PROPOSED AMENDMENT NO. 4

Part B, License Application  
AEC Docket No. 50-29

YANKEE ATOMIC ELECTRIC COMPANY

FIG. 8

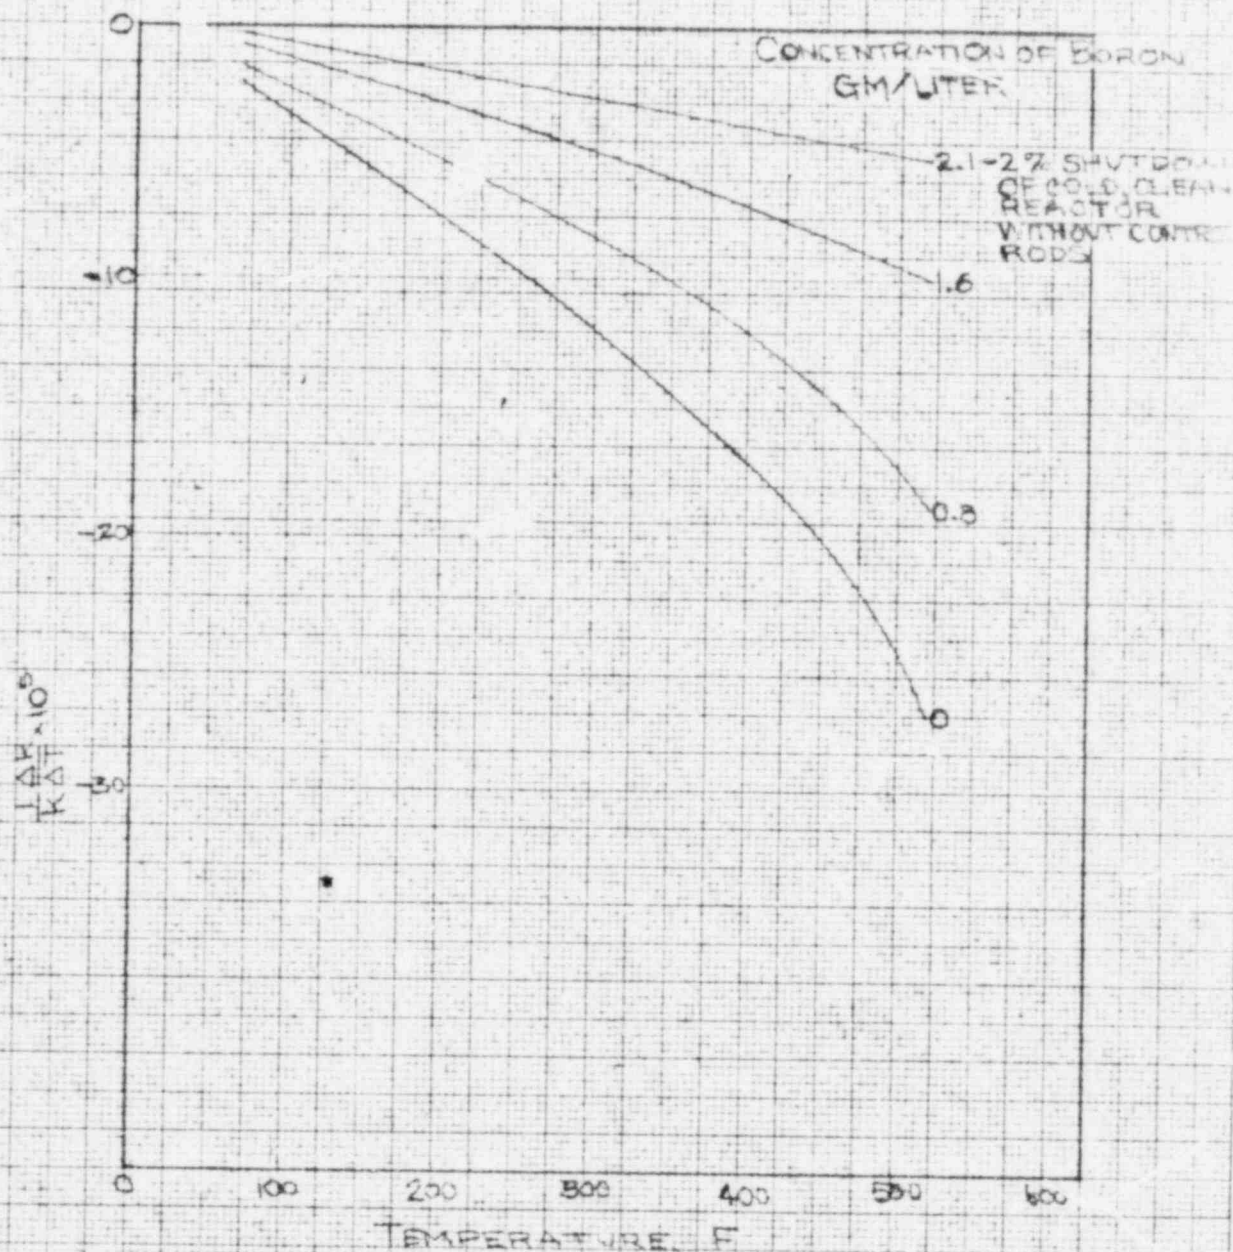
Figure 8 shows the temperature coefficient of reactivity vs temperature at several boron concentrations. Figure 8A shows the temperature coefficient of reactivity vs boron concentration at three different coolant temperatures. It should be noted that the reactor is always subcritical at boron concentrations which could result in positive temperature coefficients, even with all control rods withdrawn.

FIG. 9

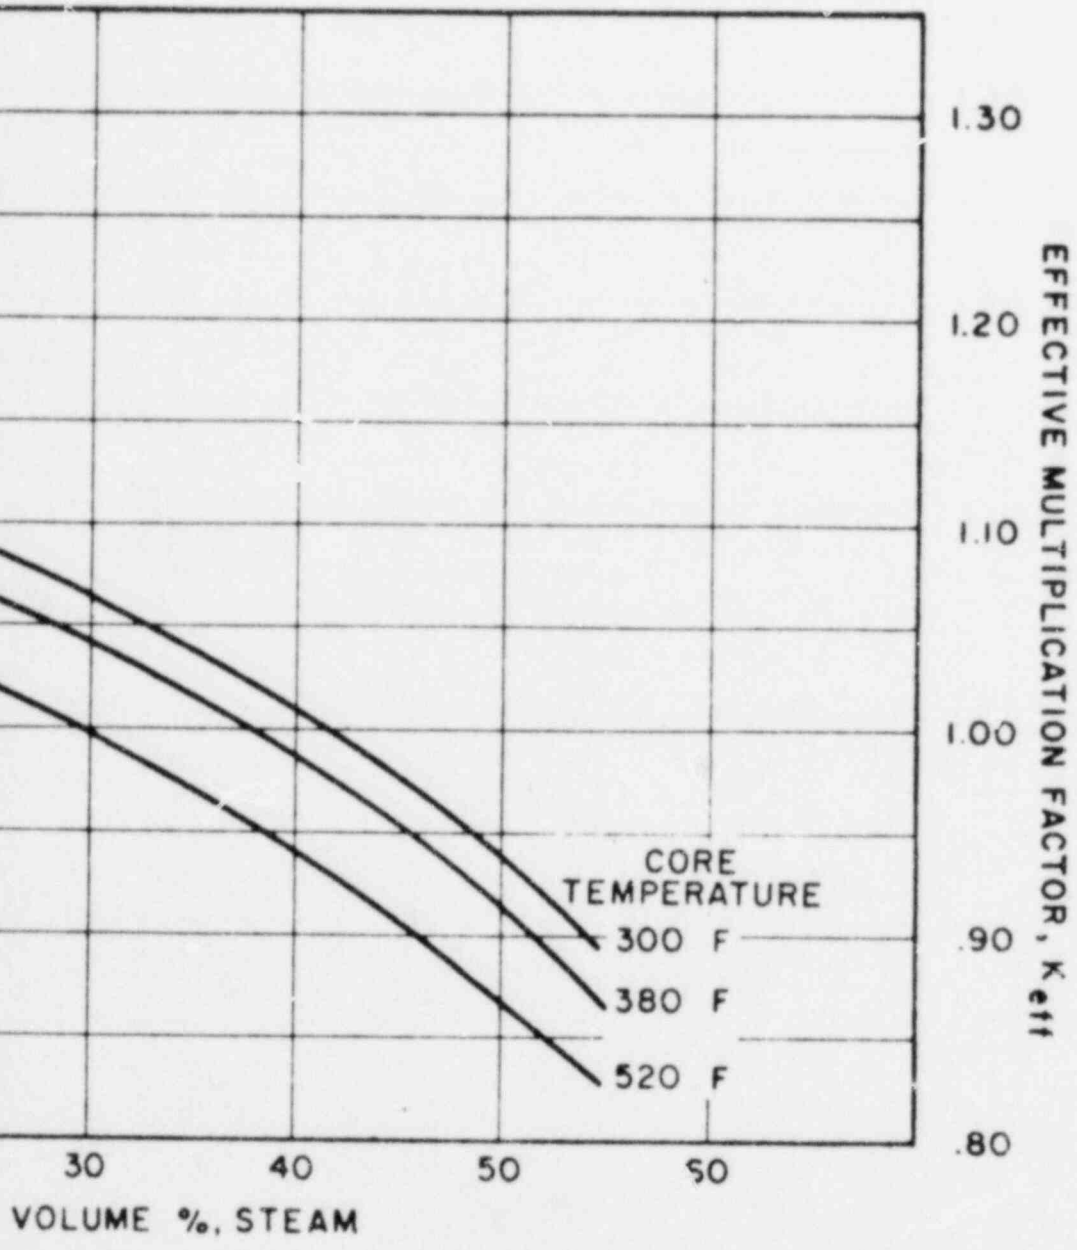
The reactor core is designed so that, in normal operation, bulk boiling does not occur even in the hottest channel. Under accident conditions, however, it is conceivable that bulk boiling may occur. The reactivity of the reactor then may be expected to be altered by the presence of steam voids. The effect of steam voids on reactivity is evaluated quantitatively and expressed as a coefficient of reactivity. In the operating range where the average temperature of the coolant is 508 F, the void coefficient of reactivity is negative with a value of  $-0.3\% \Delta k/k$  per % void. When there is no chemical poison in the coolant the effect of voids on the  $k_{eff}$  of the core without chemical poison is shown in Figure 9 in which curves are plotted for three mean core temperatures. As the temperature of the reactor is lowered,  $k_{eff}$  increases and more reactivity becomes available; therefore, a larger per cent void is required to shut down the reactor.
